From: 함재준
Sent: Thursday, June 26, 2008 11:45 PM
To: PCTEST TCB
Subject: Re: Questions Regarding FCC ID: A3LSWDI8510
Attachments: FCC SAR Report (I8510).pdf; 10_Bluetooth.pdf

RE: FCC ID: A3LSWDI8510

Subject: Request for additional information

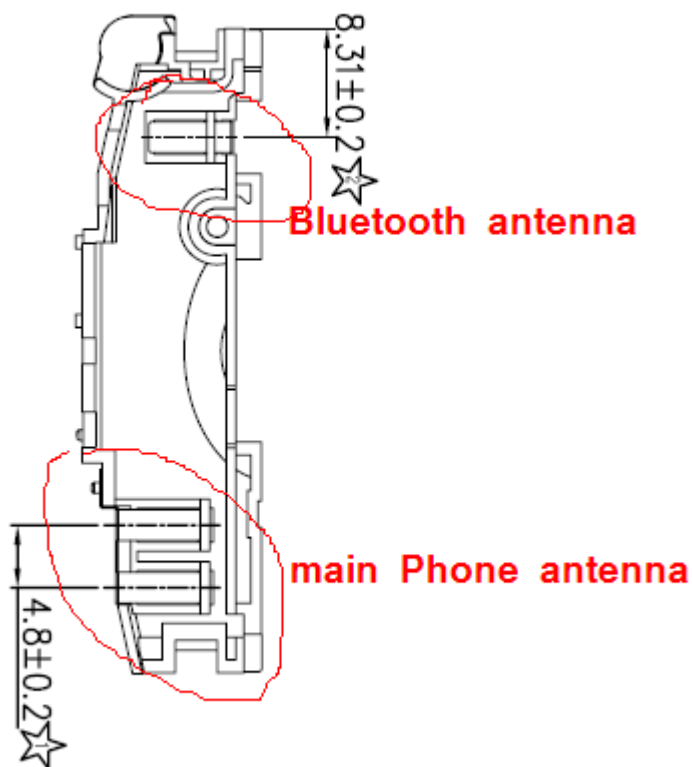
1. Please resubmit the Bluetooth Block Diagram, including all of the clocks/oscillators, as required.
==> Please find attached file.
2. The Bluetooth document includes specs for the licensed antenna, not the BT antenna. Please describe the BT antenna. What is its gain?
==> Please refer to the below image. BT antenna is located on same pattern with Main antenna.
BT gain : -5.5dBi
